REQUEST FOR PROJECT REVIEW

Please incorporate the project number somewhere.

RIVERSHORE PATH &
VILLAGE WALKWAYS

SECTION F- F1
EASTERN SIDEWALK WITH PARKING

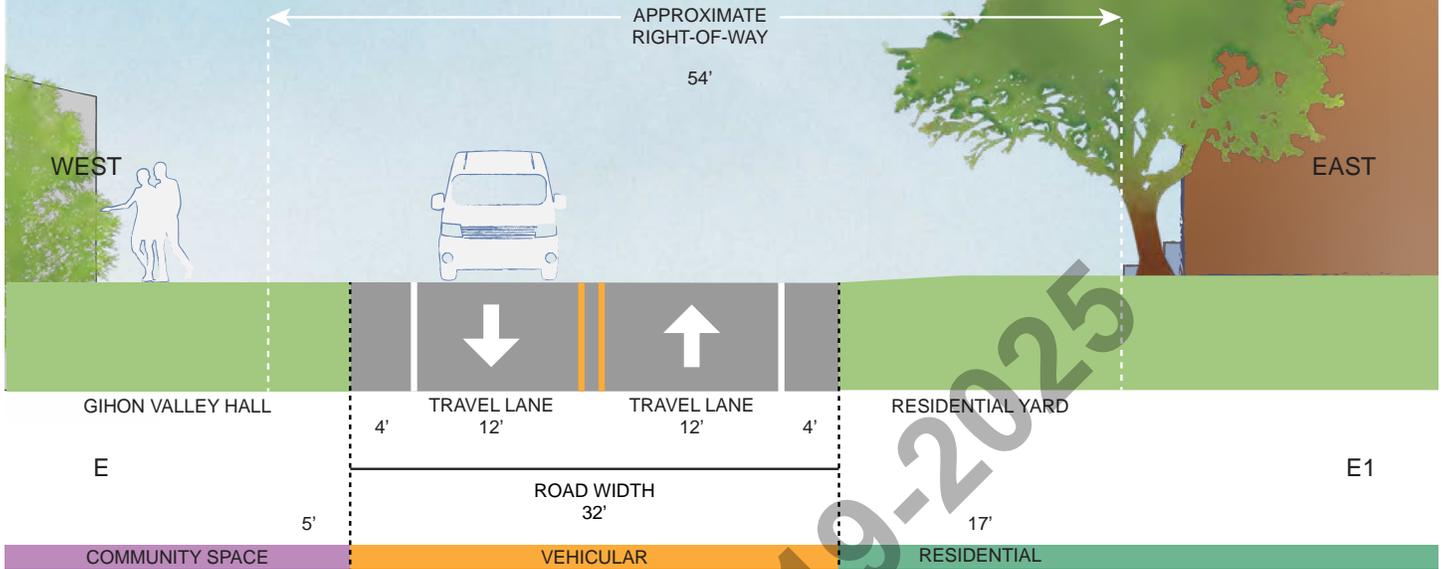
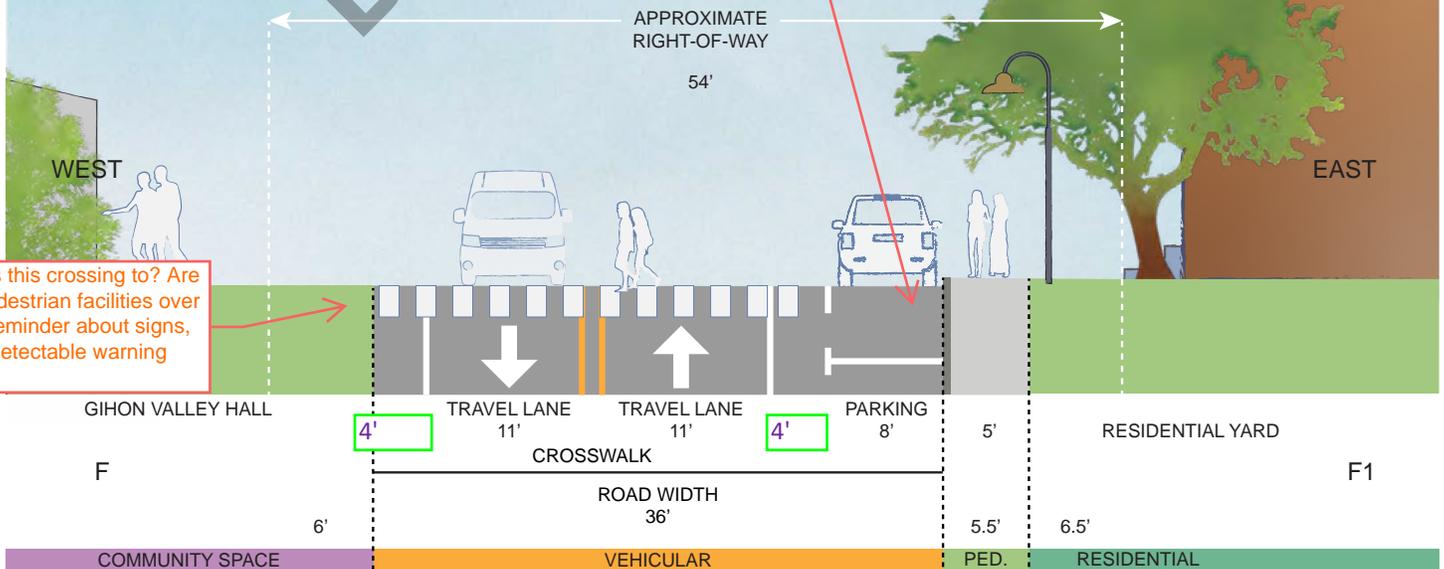
How will the crosswalk interact with parking? I believe parking is prohibited for 20 ft in advance and maybe 10 feet after a crosswalk? Have you factored this into your parking numbers

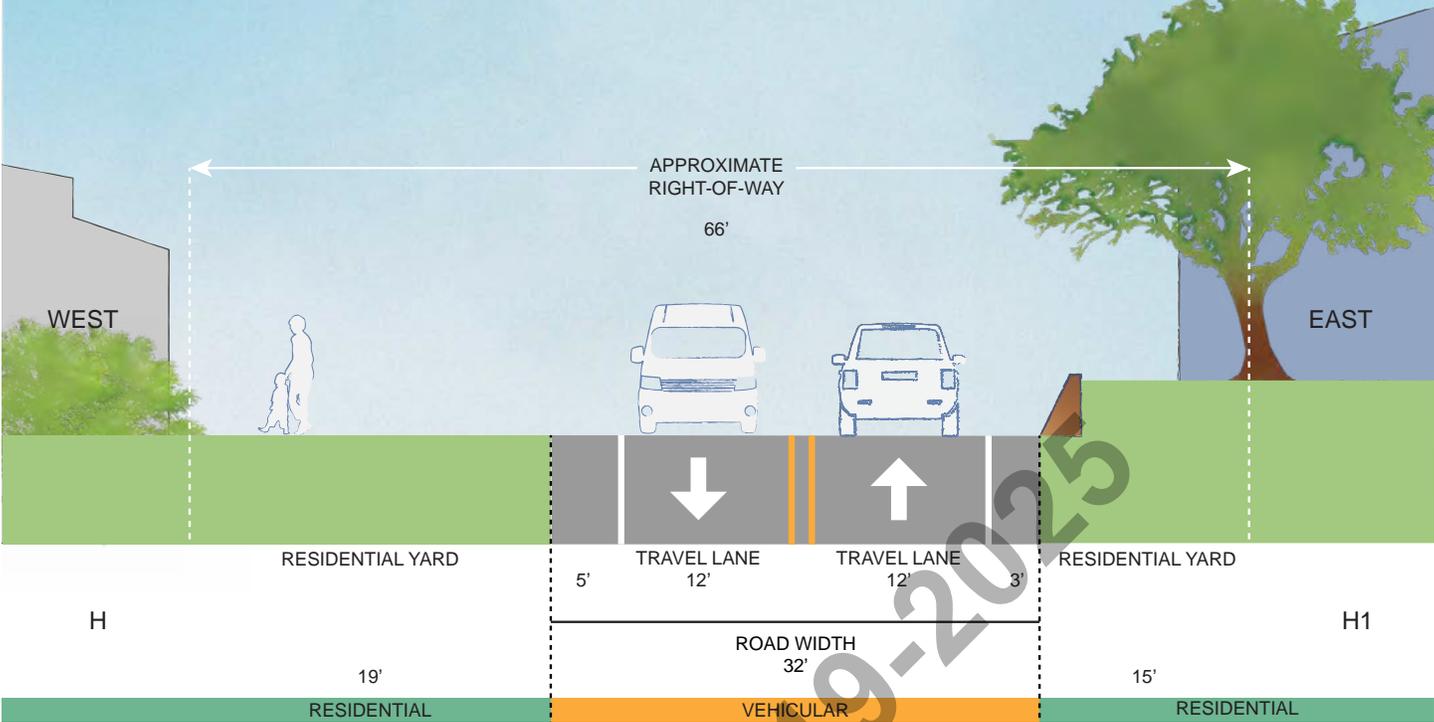
recommend that the new sidewalk be designed to pass through driveways

Unfortunately weeds will still grow in, and it will need to be mowed. It would be unrealistic to weed this, so we should expect mowing.

Not on the same side as childcare, residences, ferry st etc.
